Attachment E

Submissions

From: <[REDACTED]>
Sent on: Monday, November 4, 2024 10:27:37 AM
To: dasubmissions@cityofsydney.nsw.gov.au
Subject: D/2024/854 - 201-217 Elizabeth Street SYDNEY NSW 2000 - Attention Jessica Symons
Attachments: D 2024 854.docx (32.31 KB)

D/2017/349/A (SSD8105-Mod-1) and D/2024/854 (SSD64090972)

Figure 55 Overshadowing Diagrams – 12 and 2pm 21 June

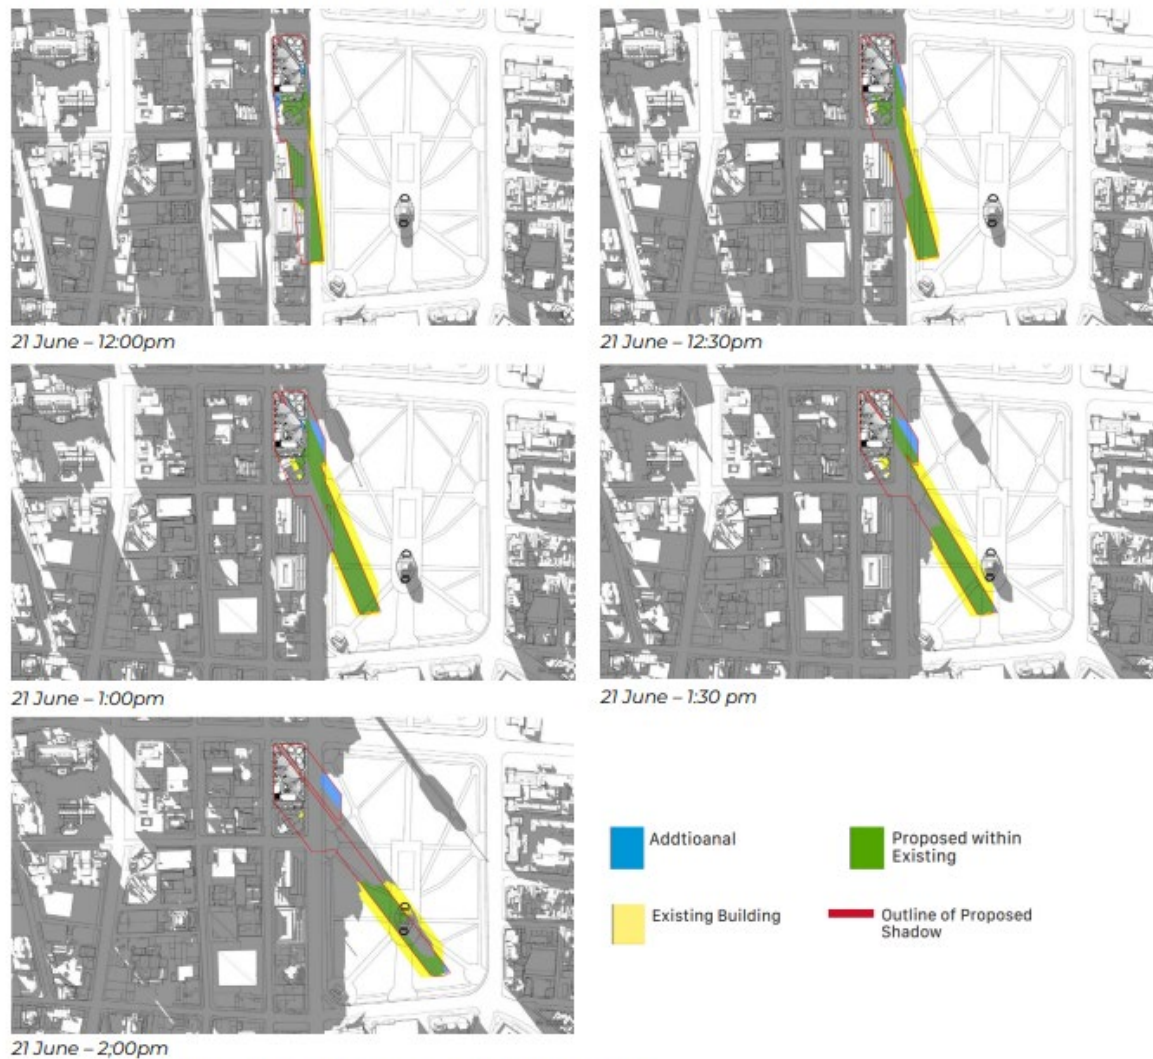
The Applicant's own shadow diagrams, Figure 55, which are reproduced below, clearly indicates significant overshadowing of Hyde Park in breach of the requirements of the Hyde Park sun access plane from 12 noon to 2 PM on 21 June (shown green). In addition, the diagrams also show new “Additional” overshadowing (shown blue) which breaches the prohibition.

The table of calculations, Table 21, establishes that the proposal would create overshadowing during the 12.00-2.00 period of 13086m², or 1.3086 hectares, during the busiest part of the day for users of the Park! The overshadowing at 13.00 to 13.30 is show as 4,031m², a greater area than the entire site at 201-217 Castlereagh Street which is 3901m².

A comparison of the overshadowing impacts of the proposed development in comparison to the existing development on the site between 12 and 2pm on t21 June are provided in **Figure 55** below.
